Addendum No. 01

File Reference Number: RFP 2026 005

Title: North Bay and Cochrane Diesel Shop Exhaust and Ventilation Upgrade

ONR DIESEL SHOP OVERHEAD DOORS

PROJECT: ONR DIESEL SHOP OVERHEAD DOORS		
LOCATION: COCHRANE, ON		
TITLE: DEMOLITION - INTERIOR ELEVATION		
DATE:	2025-09-16	
SHEET #:		S-4.1
SCALE:		As Indicated

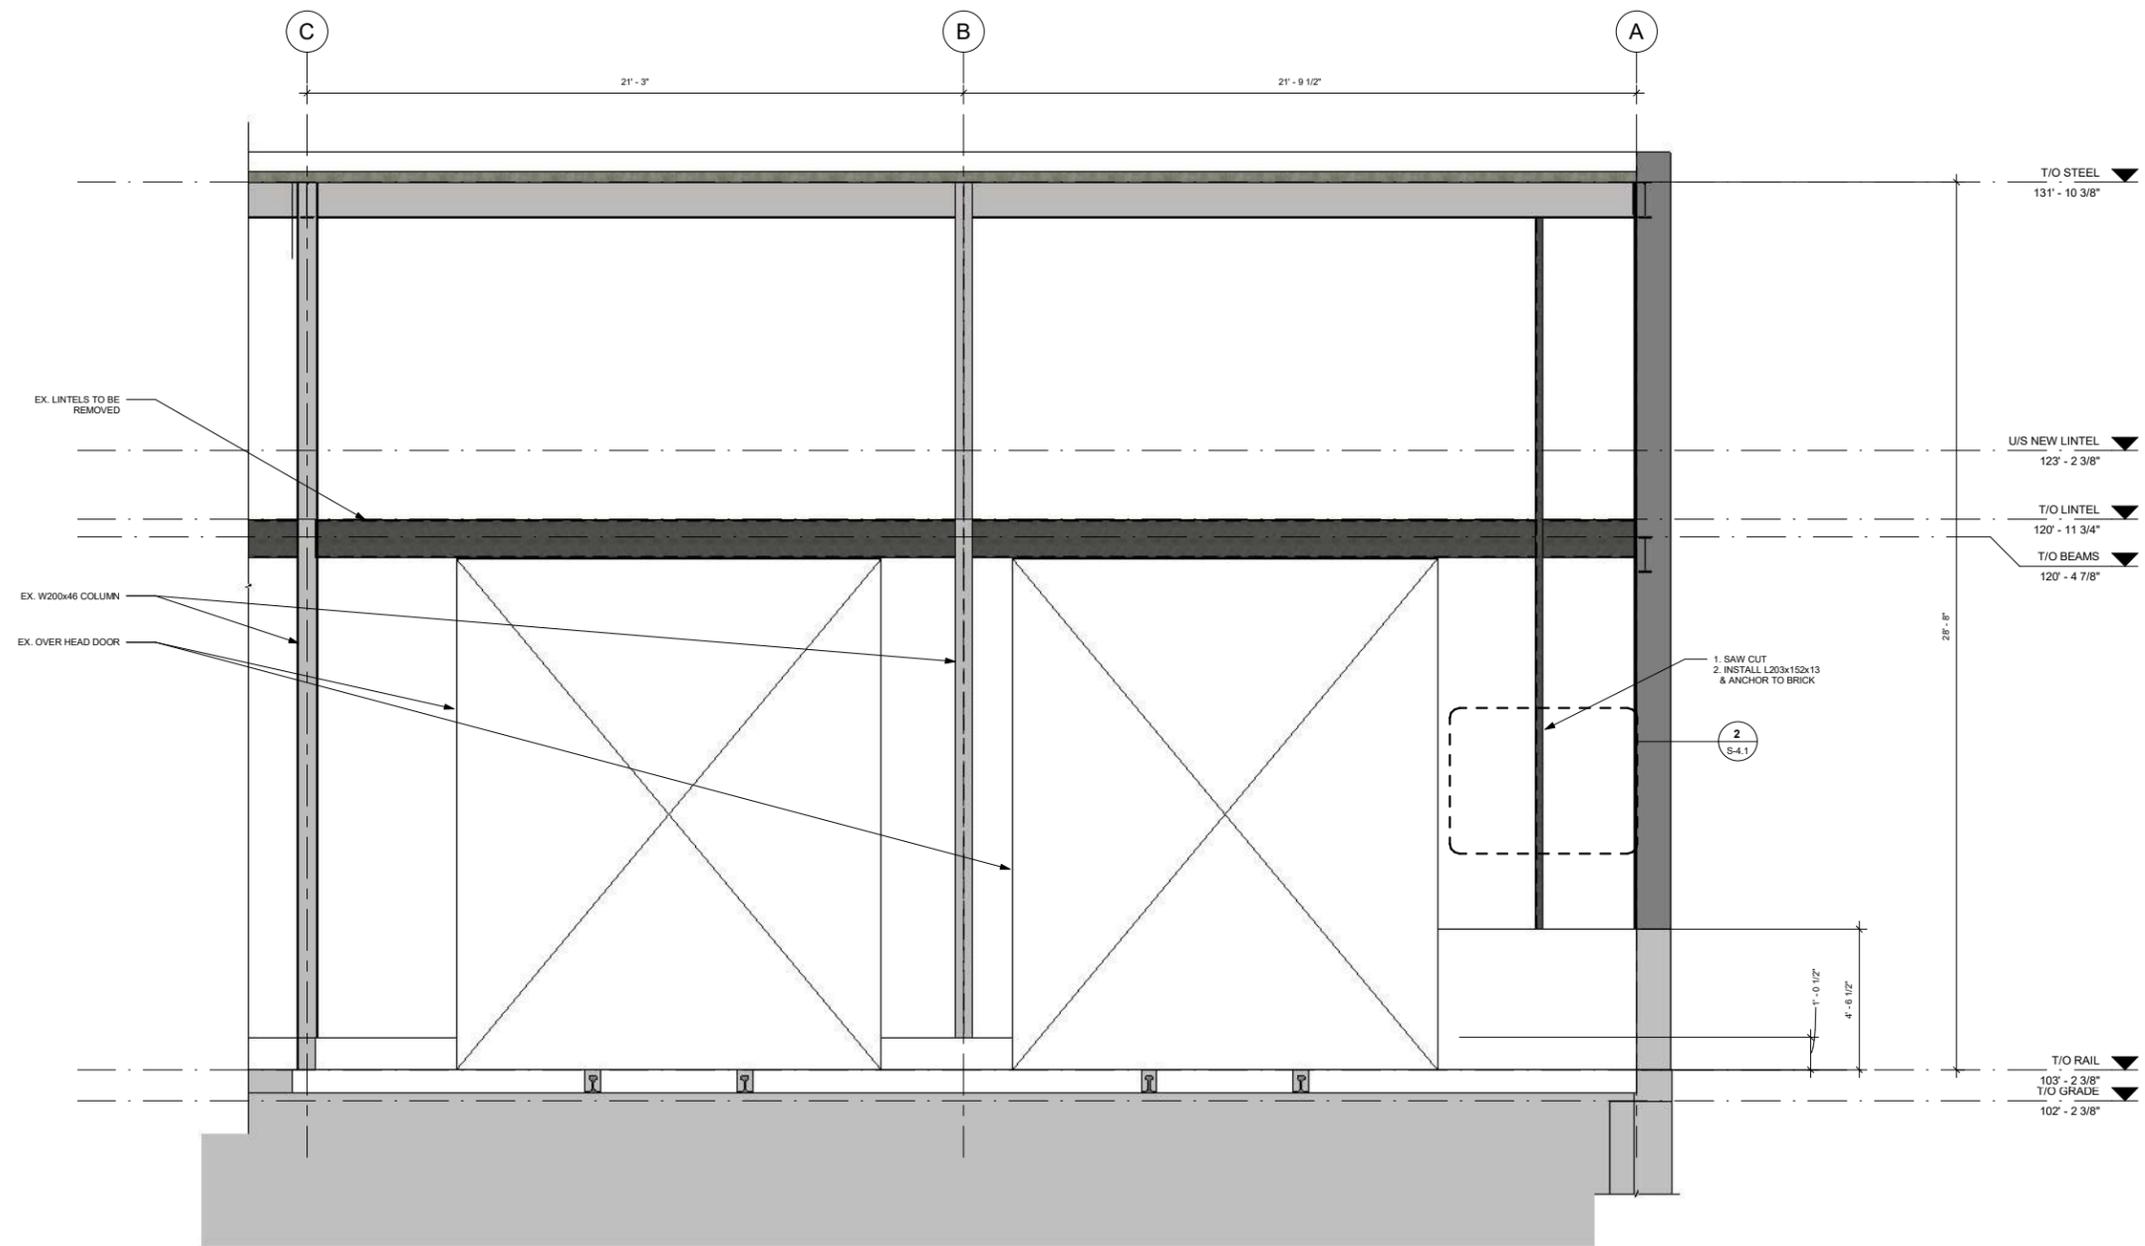
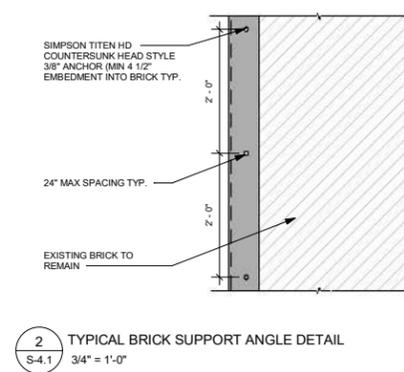
- b) Detail 2 on Drawing - S-4.1 - Highlights how to fastened the specified angle to the masonry wall.

2025-09-16	ISSUED FOR RFP	C
DATE	ISSUE	REV.
<p>PROJECT: ONR DIESEL SHOP OVERHEAD DOORS</p>		
<p>LOCATION: COCHRANE, ON</p>		
<p>TITLE: INTERIOR ELEVATION</p>		
<p>DATE: 2025-09-16</p>		
<p>SHEET #: S-4.3</p>		
<p>SCALE: As Indicated</p>

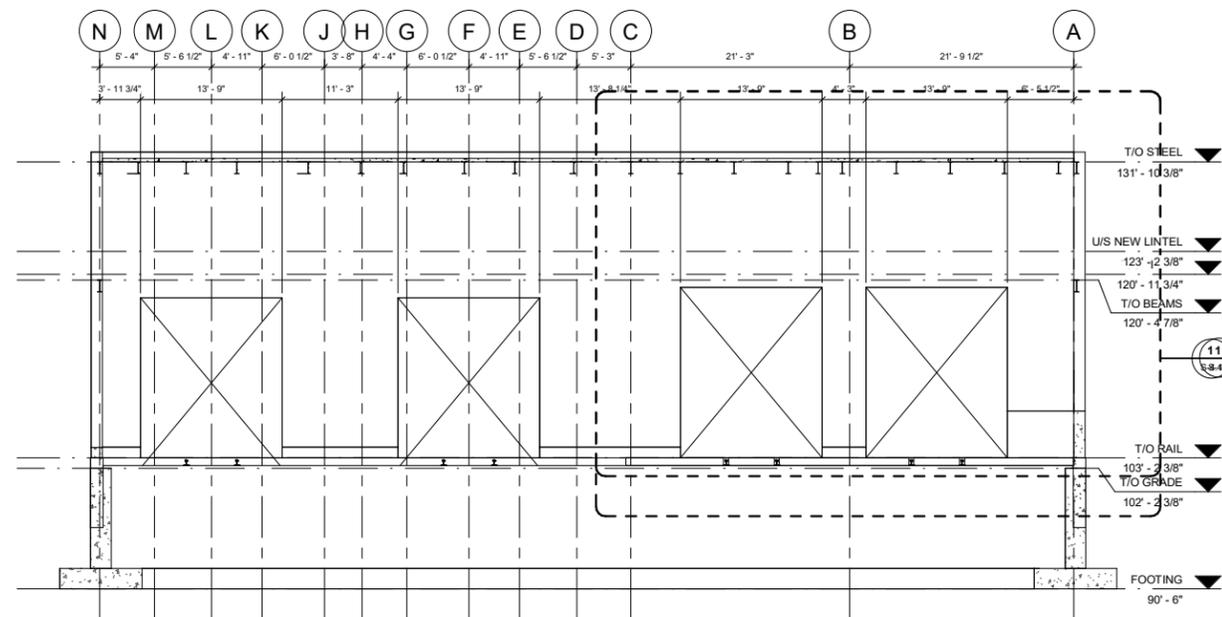
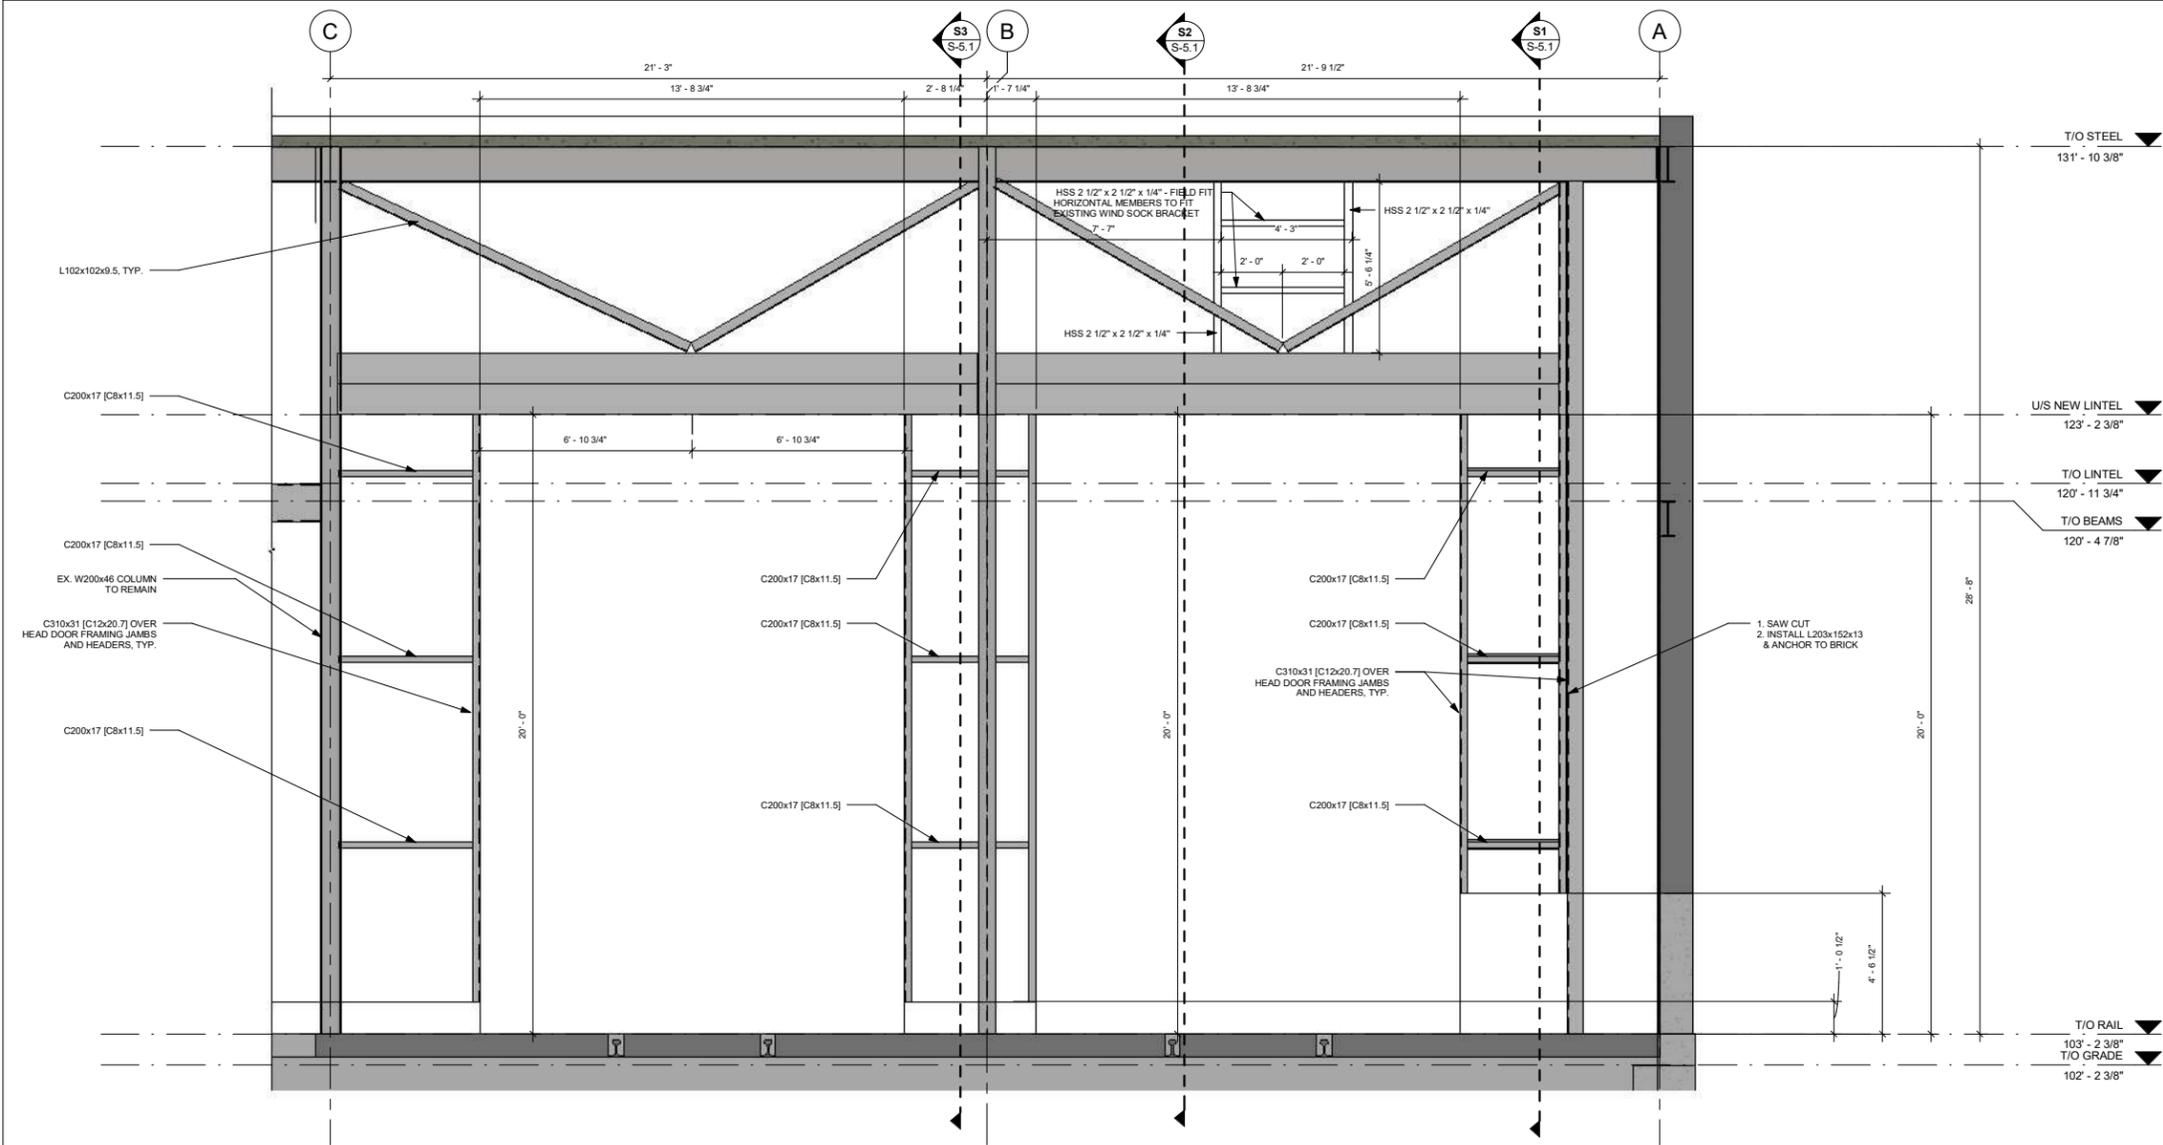
7. Clarifications for drawings:
 - a) Drawing S-4.3 - C200x17 & HSS are new. New steel is darker shade on the drawings; existing steel is light grey. Field fit HSS are shown with outlines only.
